# City of Seattle

DESIGN  
REVIEW

## RECOMMENDATION OF THE EAST DESIGN REVIEW BOARD

Project Number: 3020338

**Annotated Site Map Based on GeoEngineers' Figure 2**

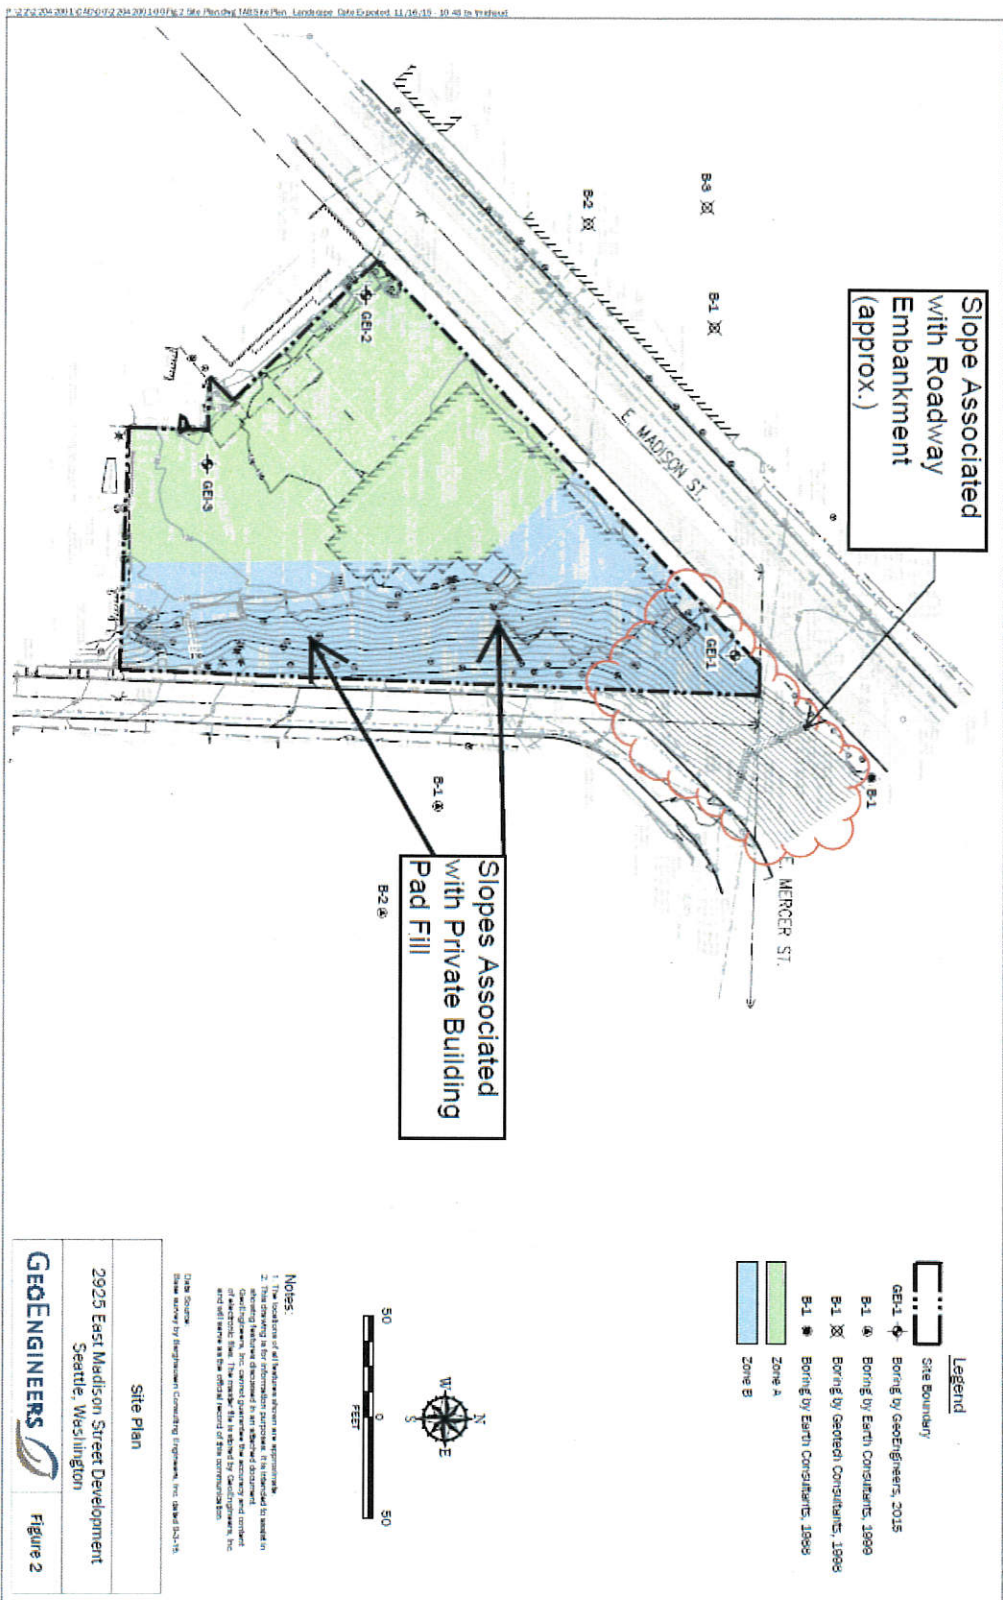
It is Ladd GEOServices' opinion that most of the existing steep slopes on the Site do not meet the criteria to provide relief from the steep slope development requirement because most of the Site's slopes were not created through previous legal grading activities and were outside the fill that would have been historically associated with the roadway right-of-way.
